Madison Parks Division

NOTICE OF ADDENDUM ADDENDUM 1

CONTRACT NO. 8228

PROJECT:
*2018 ELVER
 PARK INCLUSIVE
 PLAYGROUND*

SHEET TITLE:
*POURED-IN-PLACE
 PLAYGROUND SURFACING
 WITH UNDERDRAIN*

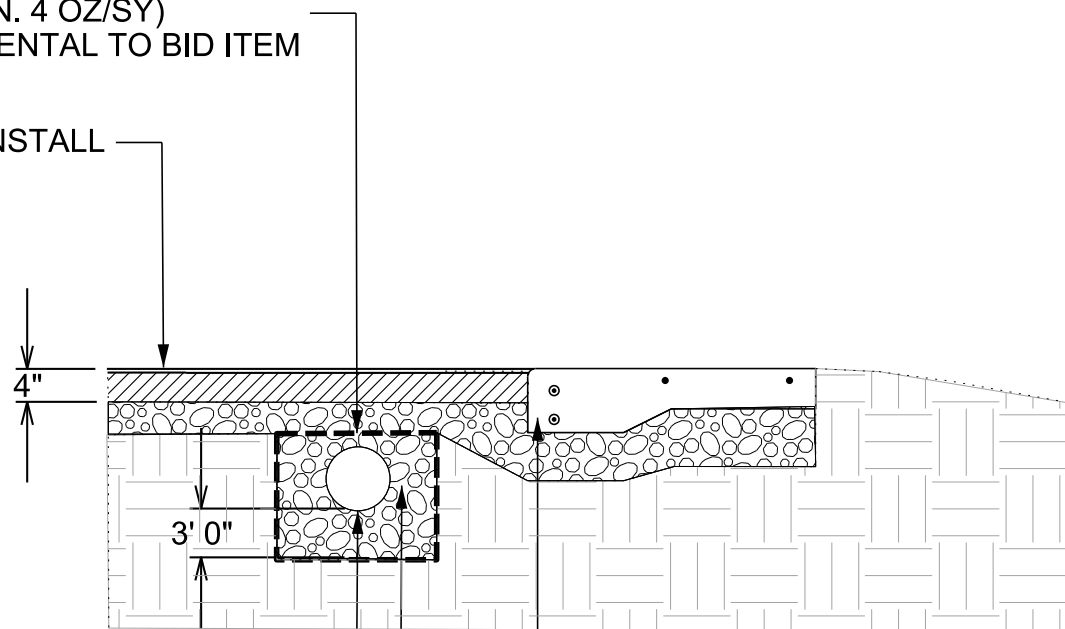
Remove and replace Sheet 1.8, Poured-In-Place Playground Surfacing With Underdrain.

Underdrain bid item was not included in the proposal page and is required.

Add BID ITEM 20130 - UNDERDRAIN. BID ITEM 20130 is listed, below and has been added to Section B: Proposal Page on BidExpress.
